Transport Impact Assessment

Proposed Residential Hotel Development

253 Barnard Street, 144, 152-156
Wattle Street, Bendigo

9. Response to DTP comments

Figure 9-2: Relocation of Existing On-Street Parking Spaces

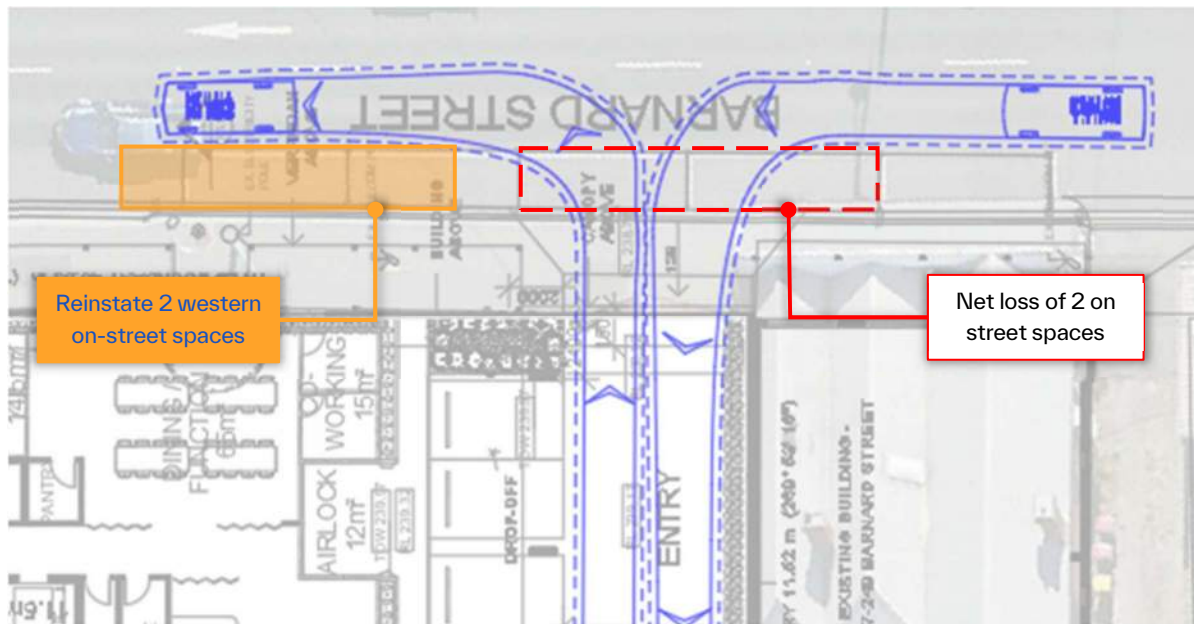
1. On-street Parking and Sight Distance

As demonstrated in the swept path planning (as attached in Appendix B), three existing on-street parking spaces as identified in Figure 9-1 below would be required to be removed to facilitate vehicle entry and exit via the proposed north-eastern crossover. The removal of these spaces is necessary to accommodate the turning path of the 8.8 m Medium Rigid Vehicle (MRV), during entry and exit manoeuvres in accordance with the design vehicle requirements.

There would be an opportunity to reinstate some of the on-street parking spaces while maintaining simultaneous vehicle entry and exit movements, resulting in a net loss of only two spaces, by relocating the two westernmost on-street parking spaces approximately 2 metres further west of the proposed crossover, as shown in Figure 9-2.

Appendix B Swept Path Assessment

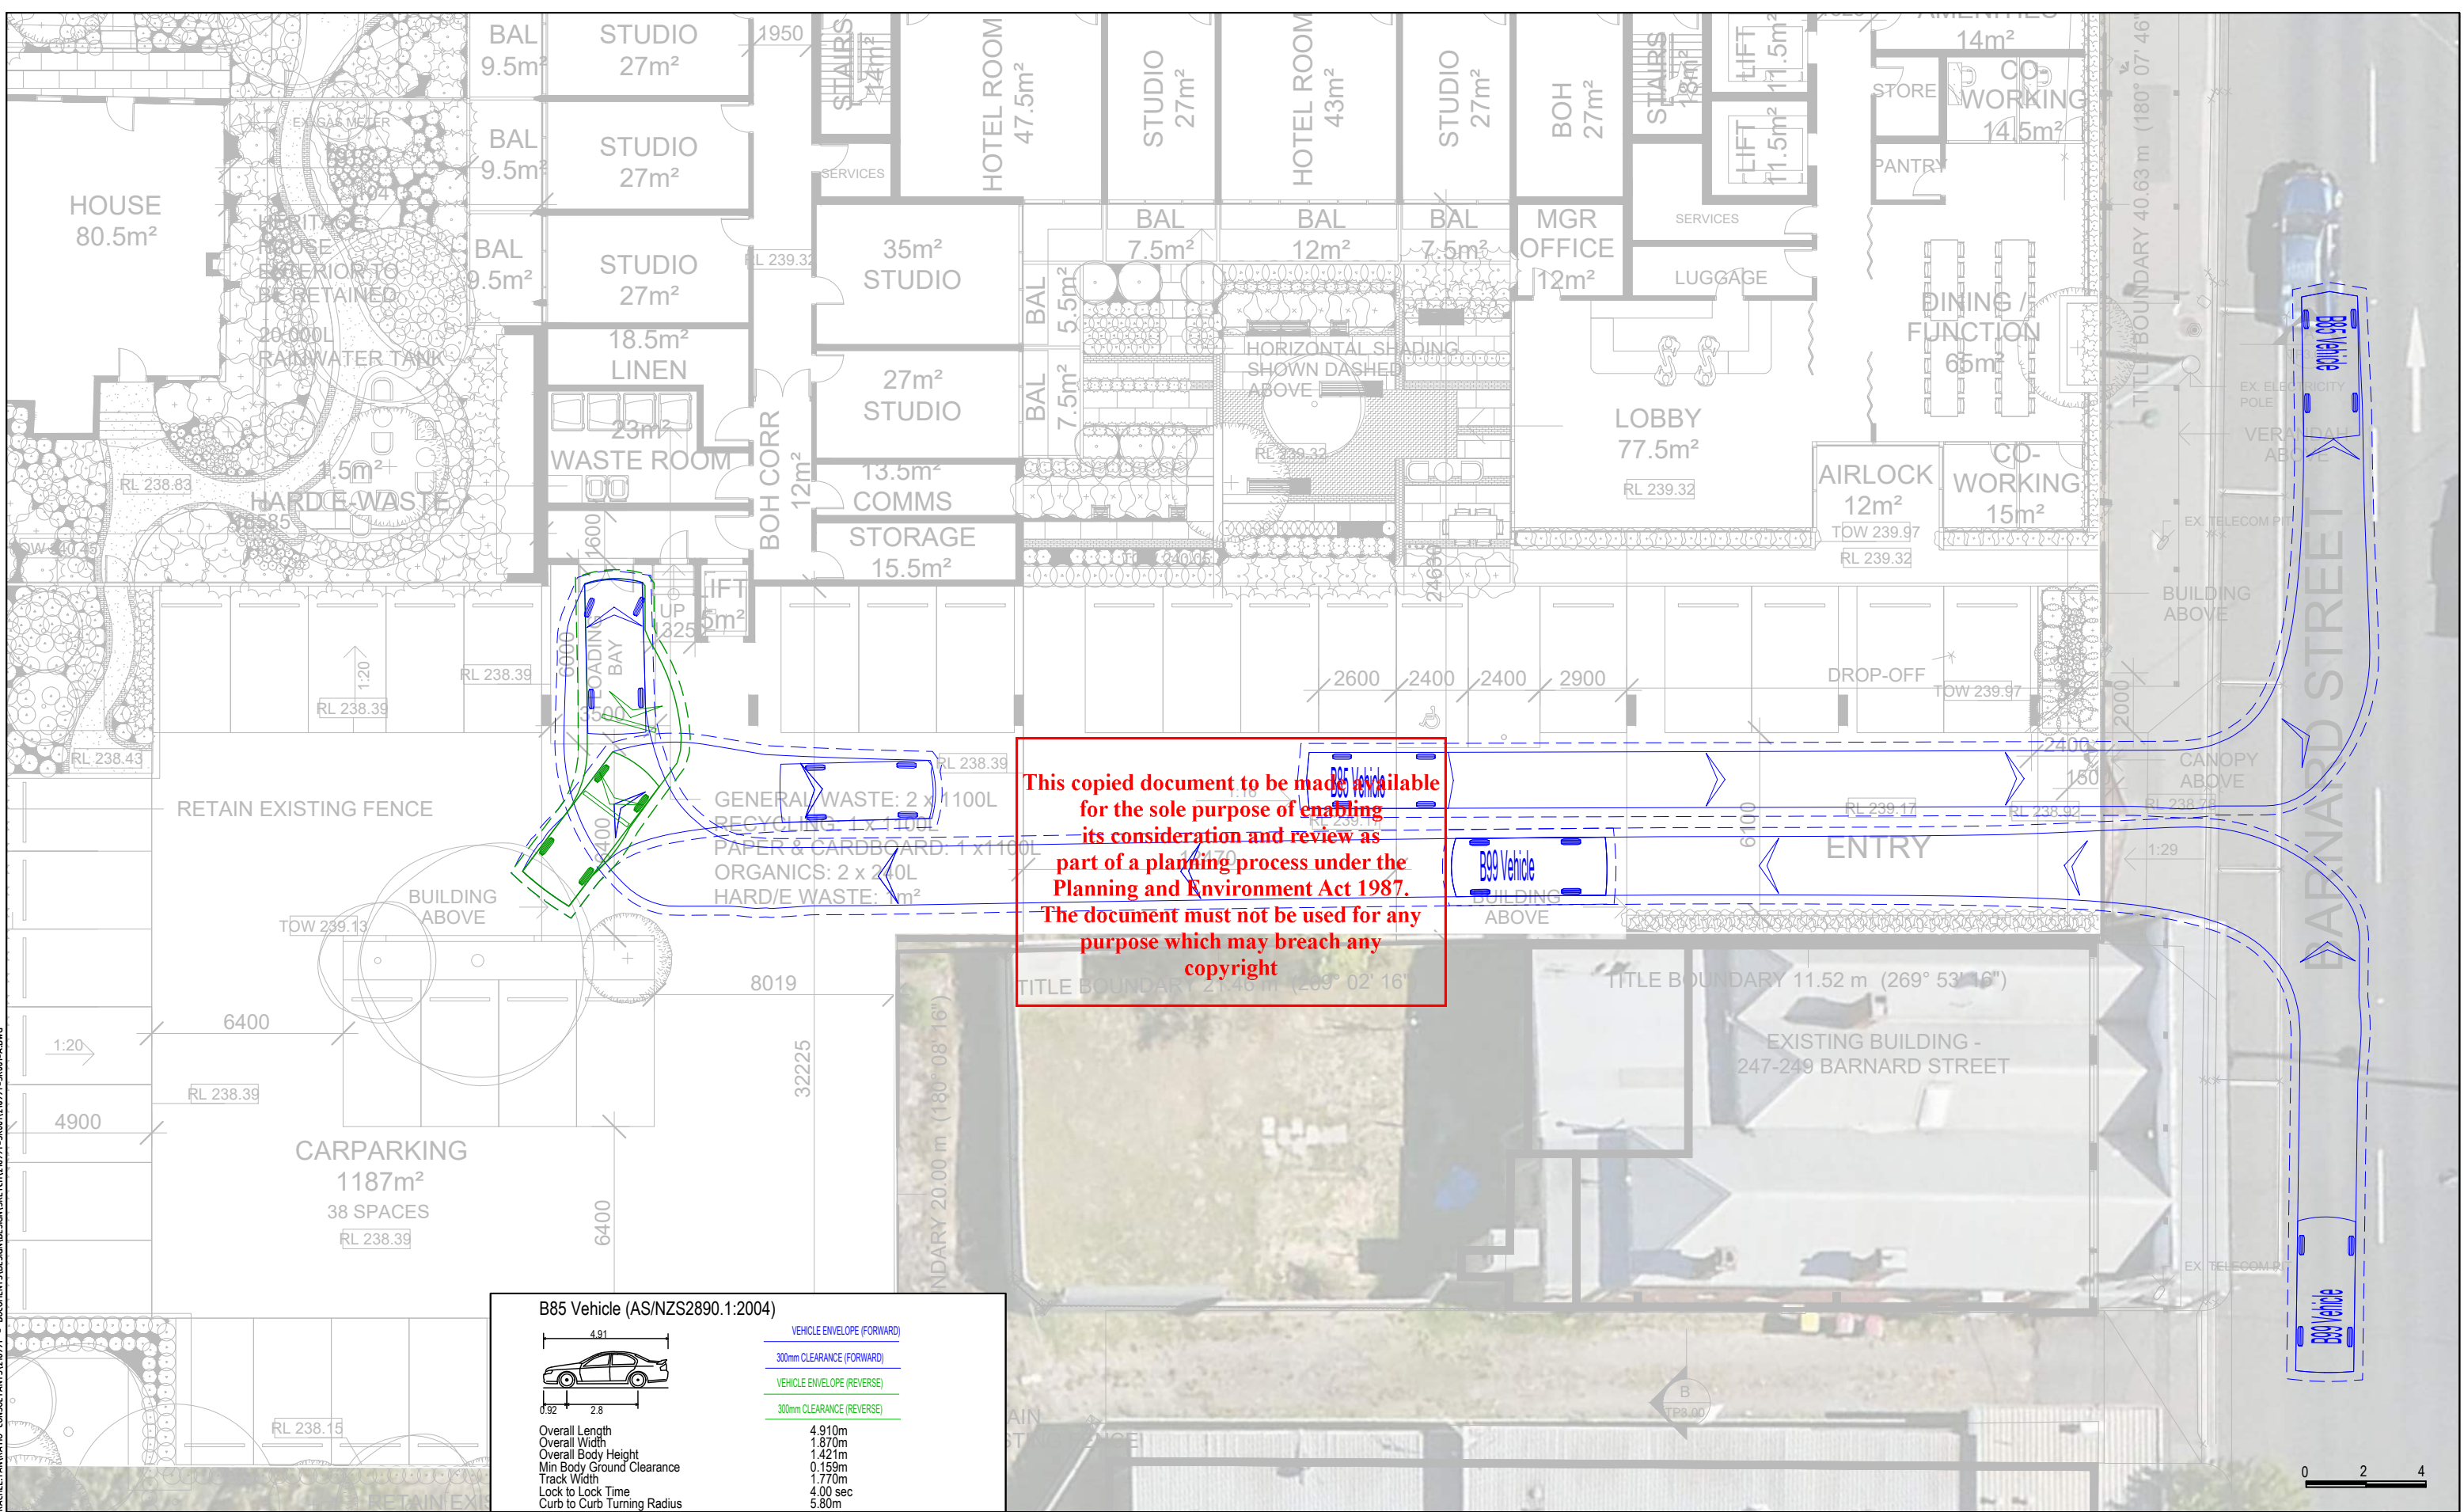
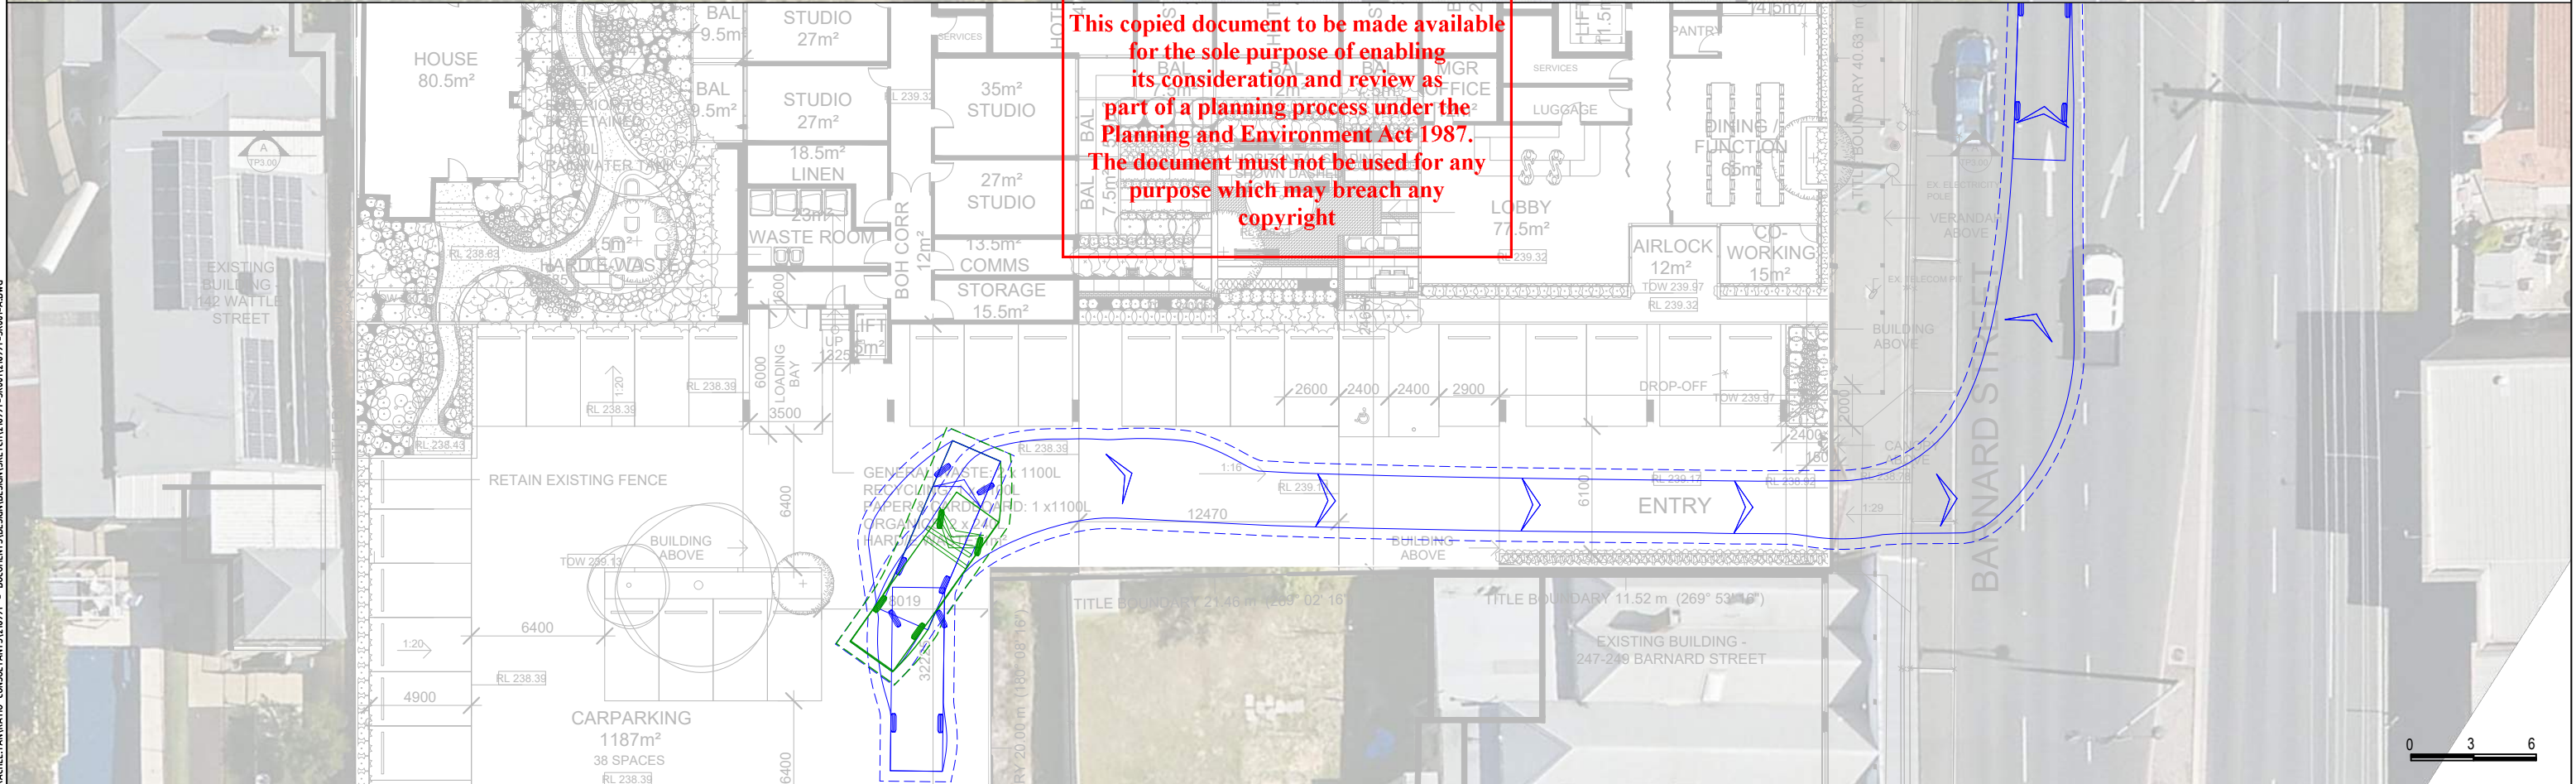
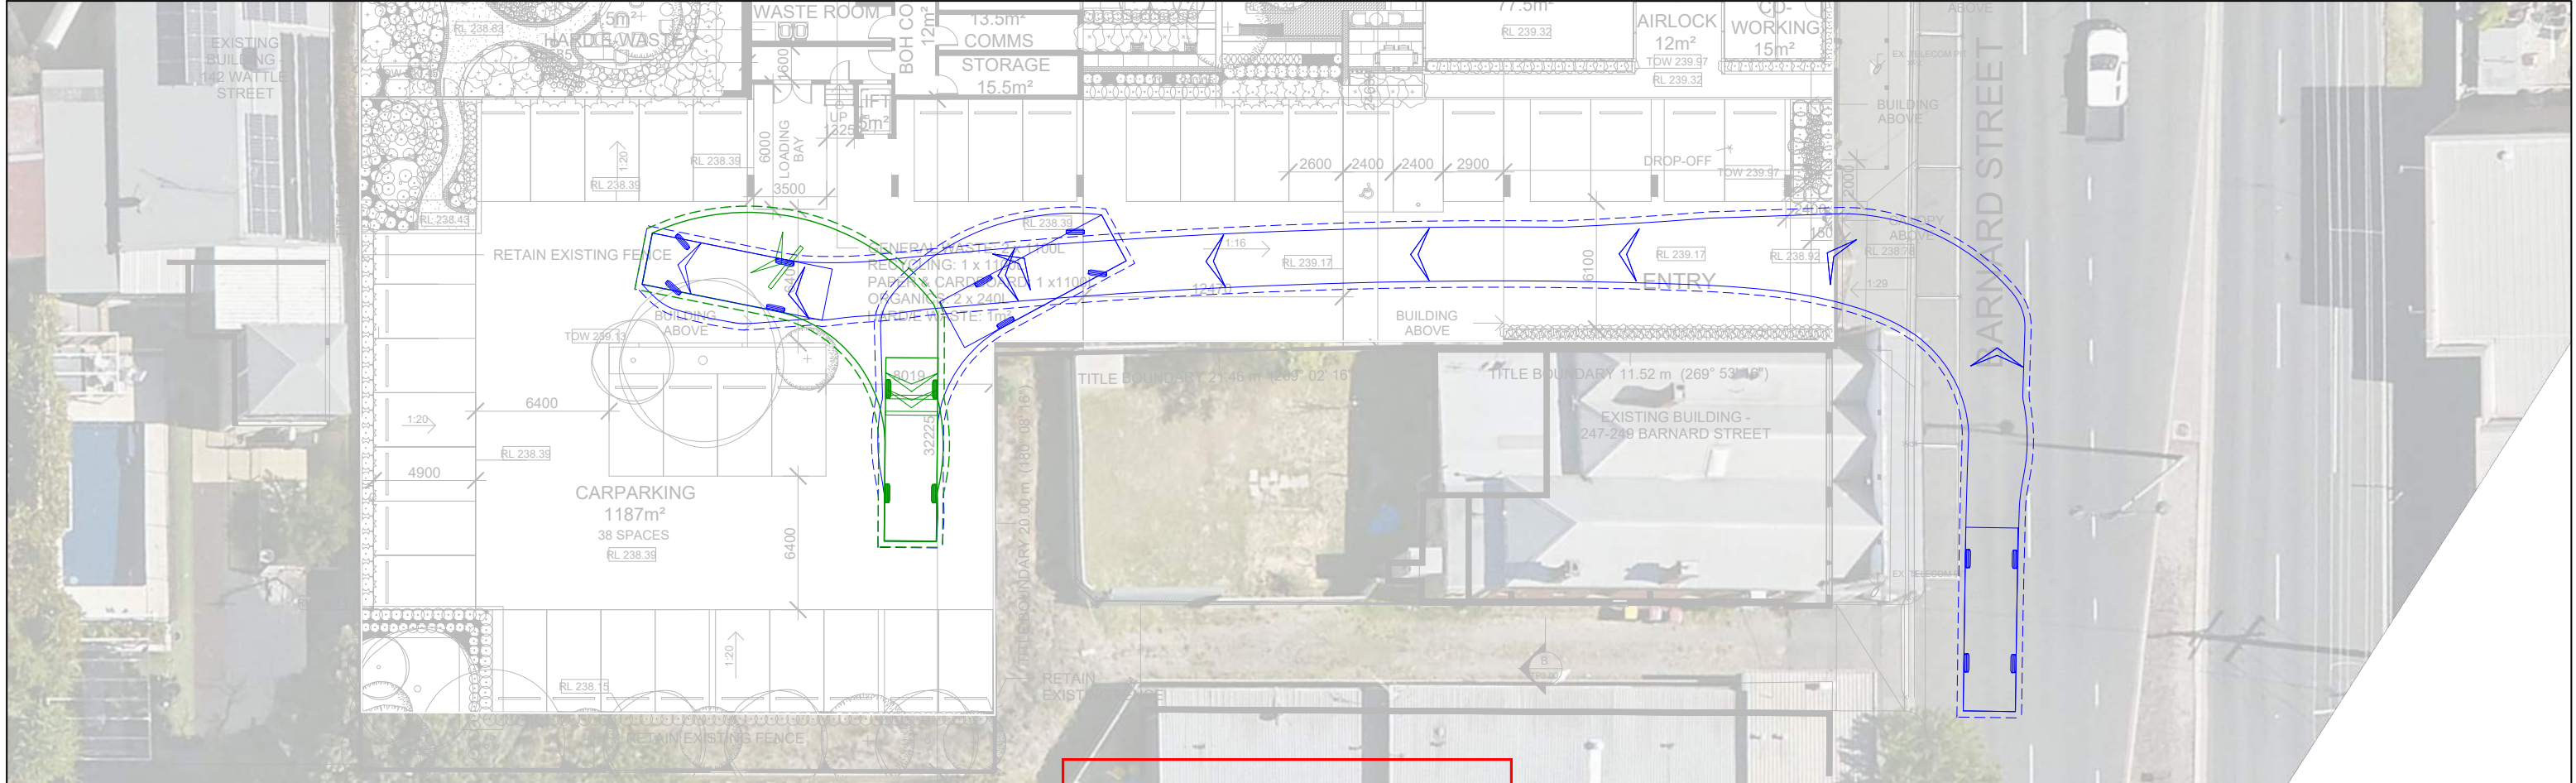
2. Swept Path Assessment

- a. The submitted swept path diagrams currently illustrate simultaneous movements of B85 and B99 vehicles at the driveway. However, additional assessment is required to demonstrate a more realistic operating scenario, specifically an 8.8 m rigid truck entering the site while a B85 vehicle is exiting.
- b. Revised swept path drawings must be provided to confirm that such vehicle movements can occur safely, efficiently and without conflict at the access point. The current assessment for the 8.8 m truck is not considered satisfactory and requires further justification of the design.

The largest vehicle anticipated to access the site is associated with waste collection which will be undertaken by an 8.8-metre-long Medium Rigid Vehicle (MRV). The swept path assessment demonstrates that this vehicle can access and exit the site in a forward direction following collection.
